City of Portland, Maine – Building or Use Permit Application 389 Congress Street, 04101, Tel: (207) 874-8703, FAX: 874-8716

REASON FOR PERMIT: Amendment for standing rails with shelves

APPROVED: with conditions

PROJECT: STATE
 THEATER
 SHEET TITLE: PLATFORM
 RAILINGS

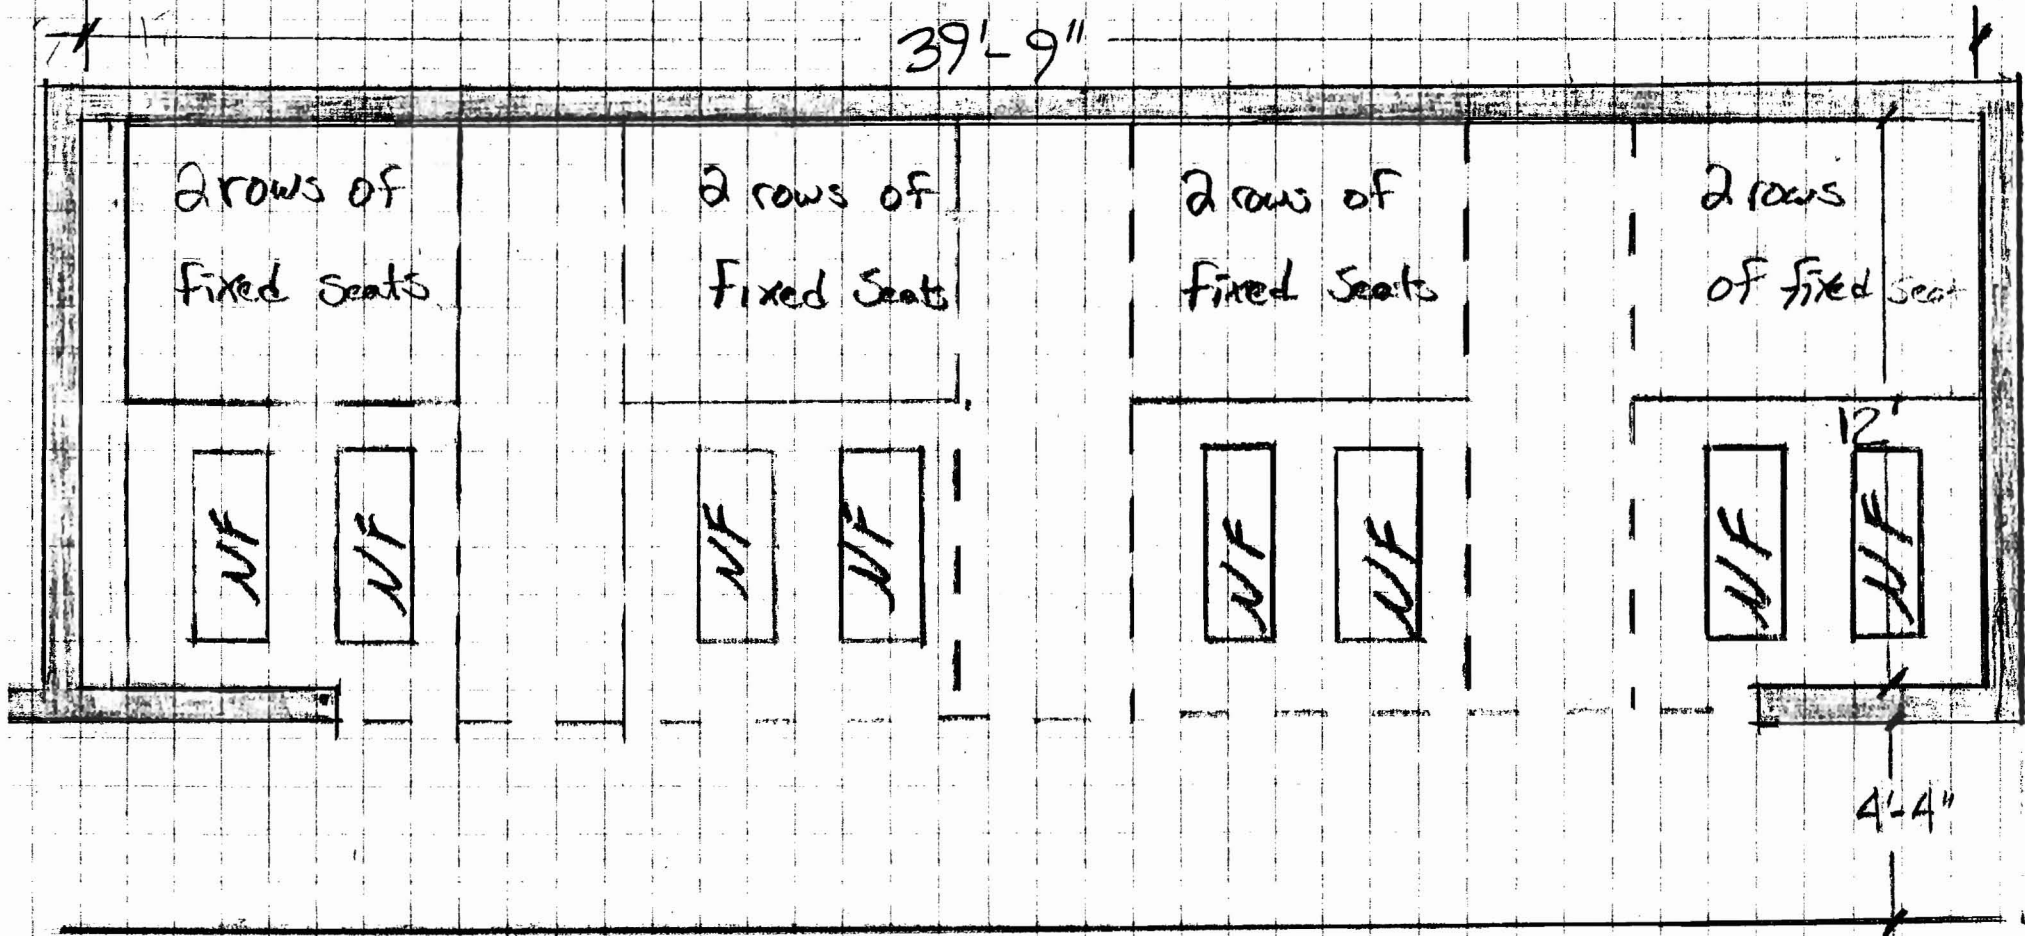
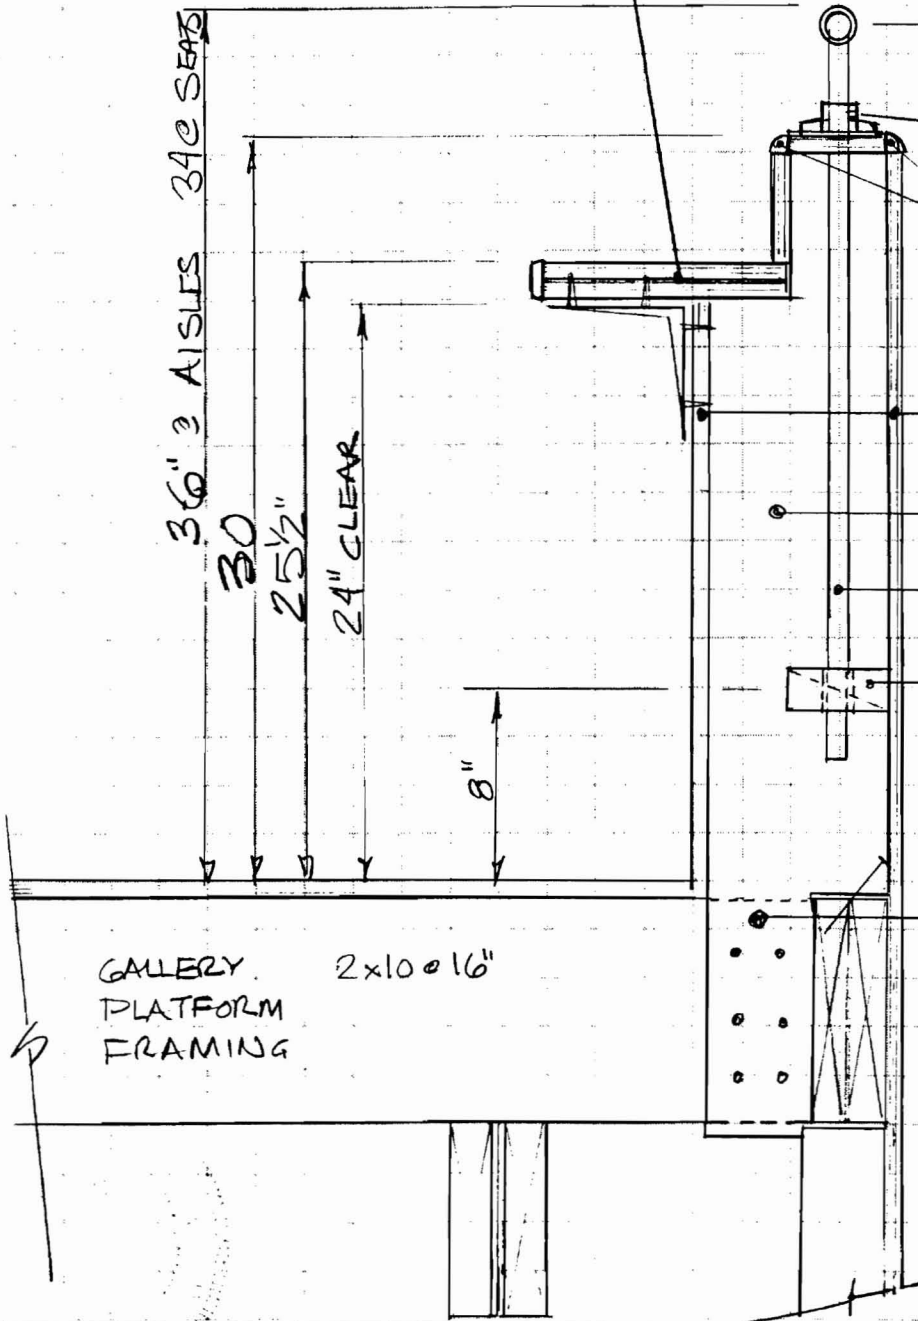
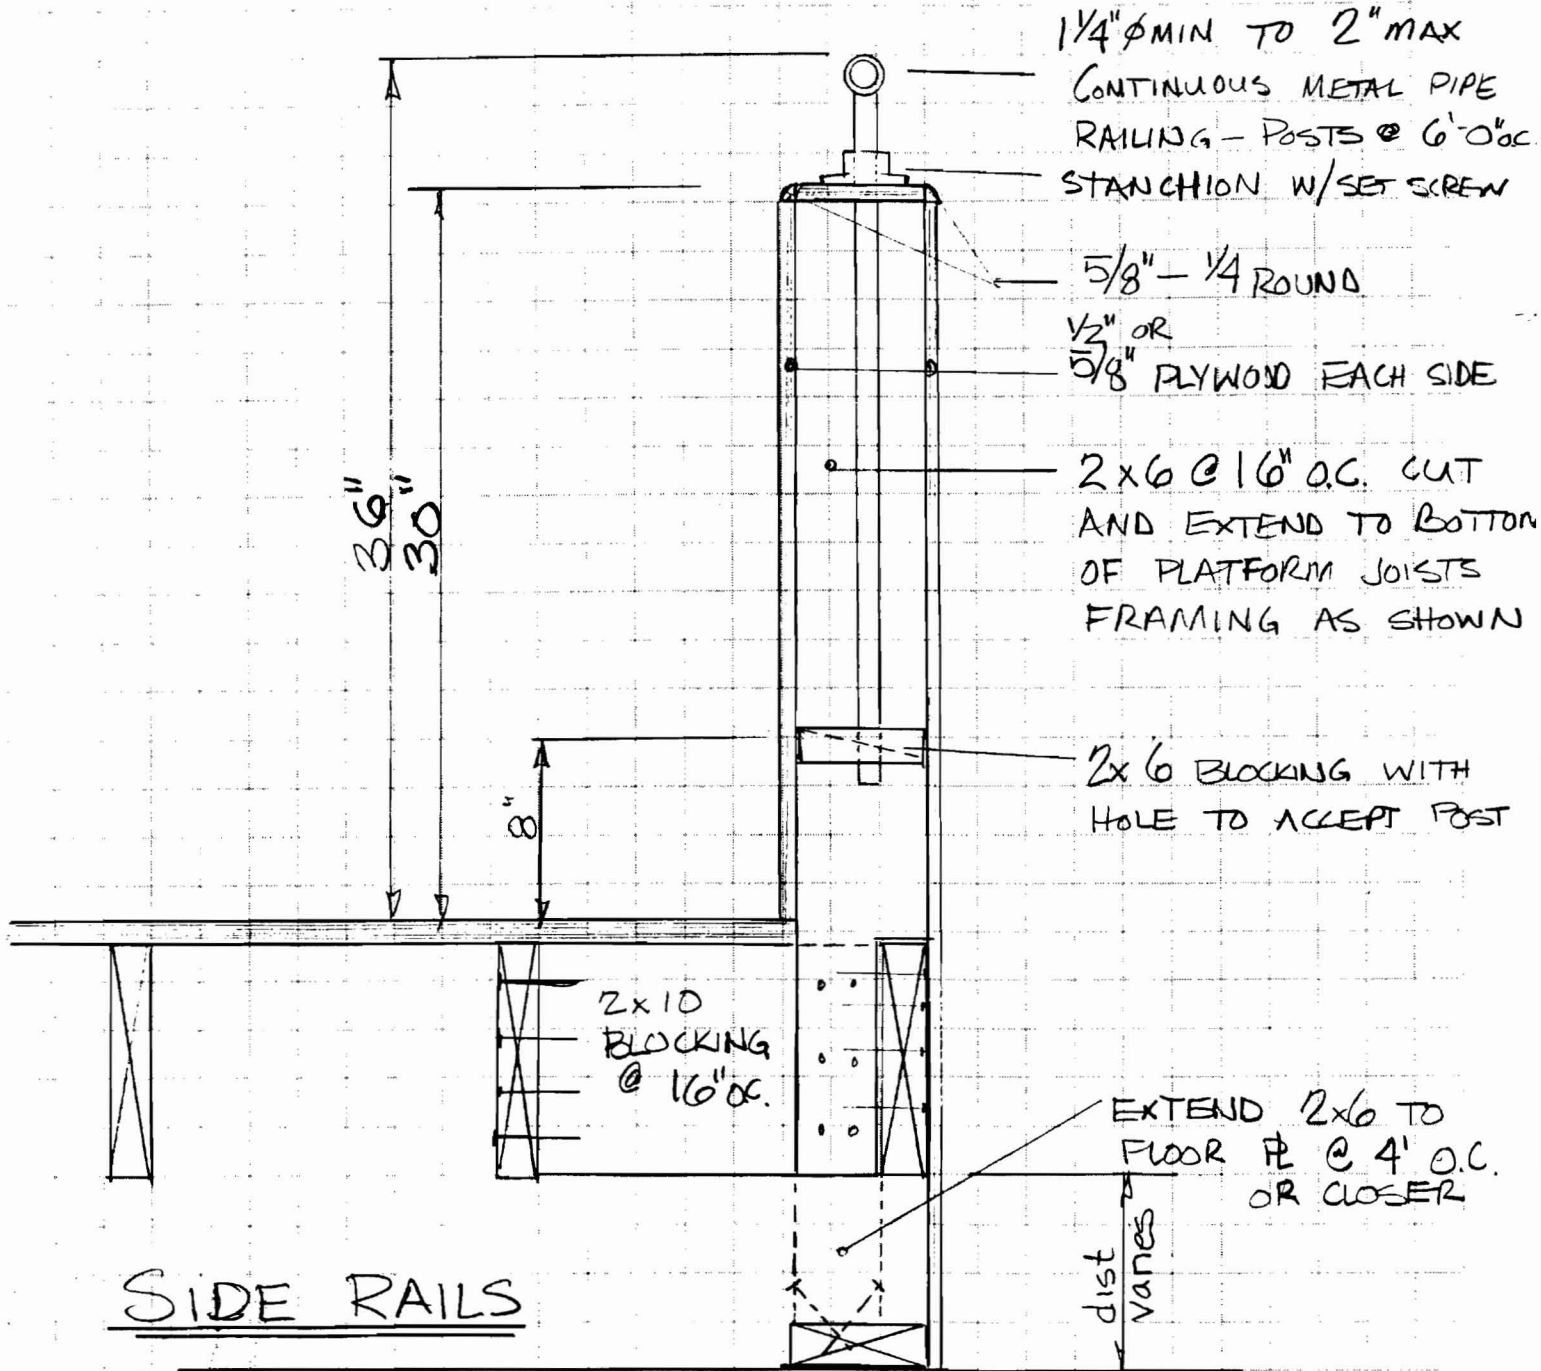
11. Other requirements of condition HA1 The principal use shall remain a SAN "Entertainment/Theatre type" use. If there is any change to use this as a bar use or restaurant use as it's primary use, a separate permit for review and approval is required!
Marge Schmuckal Marge Schmuckal, Zoning Administrator

1. This permit is being approved on the basis of plans submitted. Any deviations shall require a separate approval before starting that work.
2. During its existence, all aspects of the Home Occupation criteria, Section 14-410, shall be maintained.

3. The footprint of the existing _____ shall not be increased during maintenance reconstruction.
4. All the conditions placed on the original, previously approved, permit issued on 2/23/2000 are still in effect for this amendment. # 000135

1ST FLOOR PLAN

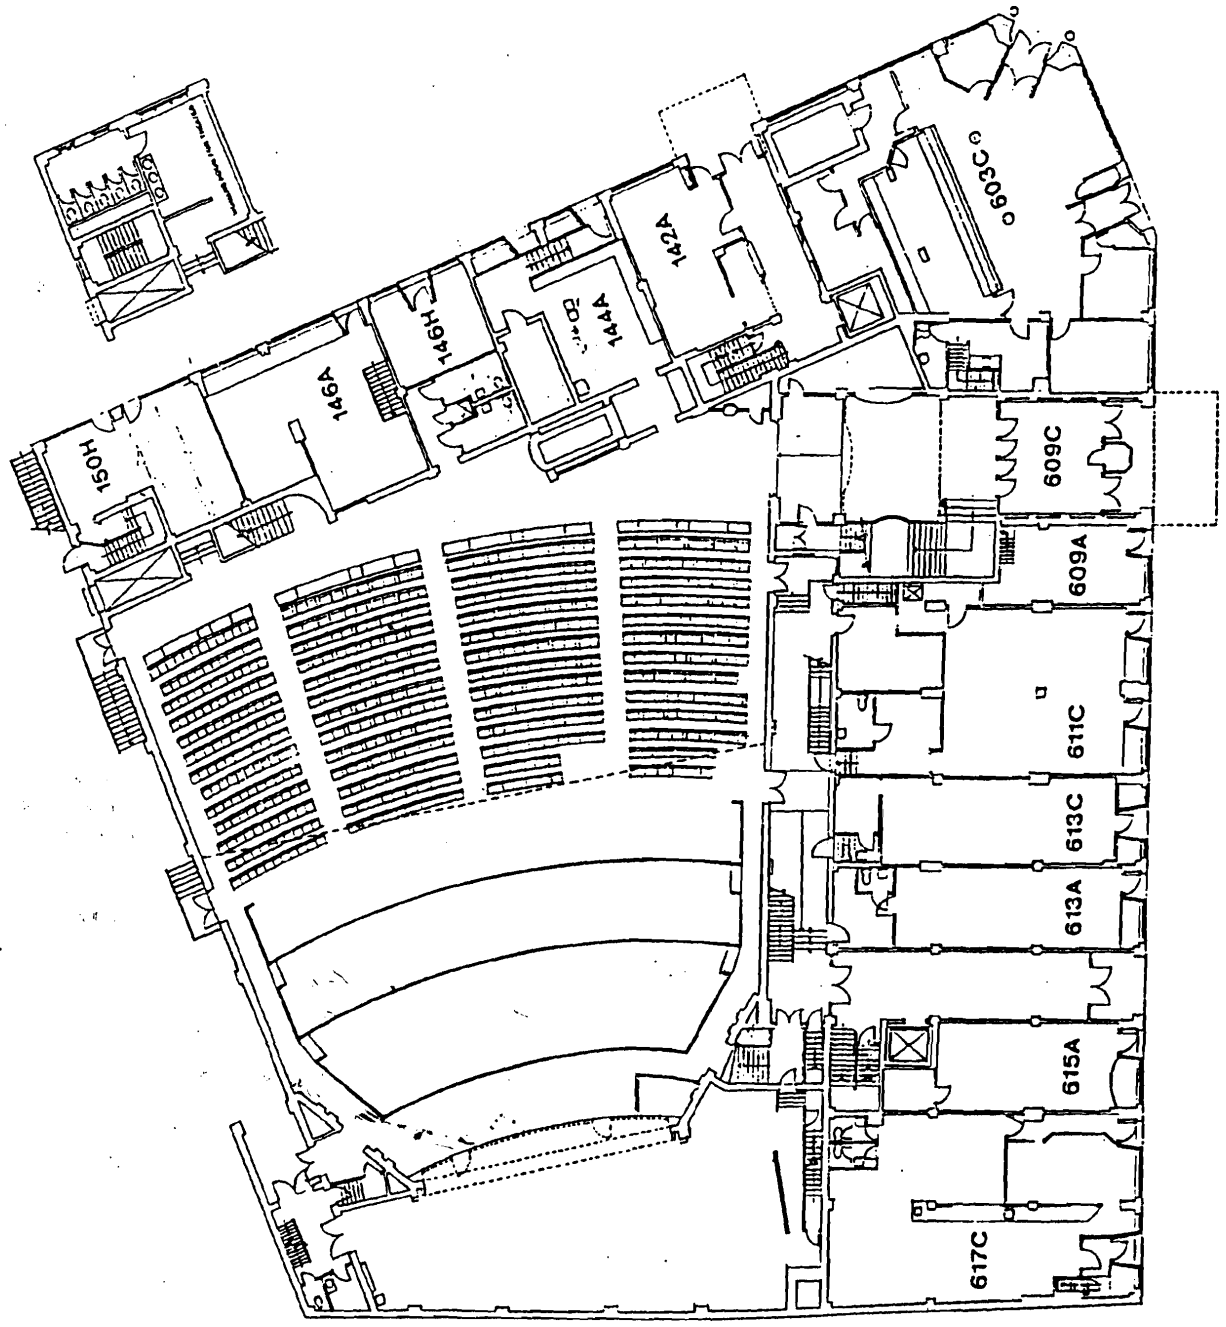
1. CONSTRUCT PLATFORM RAILINGS IN ACCORDANCE
2. WITH ASSOCIATED DESIGN PARTNERS INC. PLANS
- 3.
- 4.
5. - WITH EXTRA MATERIALS TO COST APPROX. \$3000
- 6.
7. - ALL LABOR INCLUDED IN ORIGINAL BID
- 8.
- 9.
- 10.
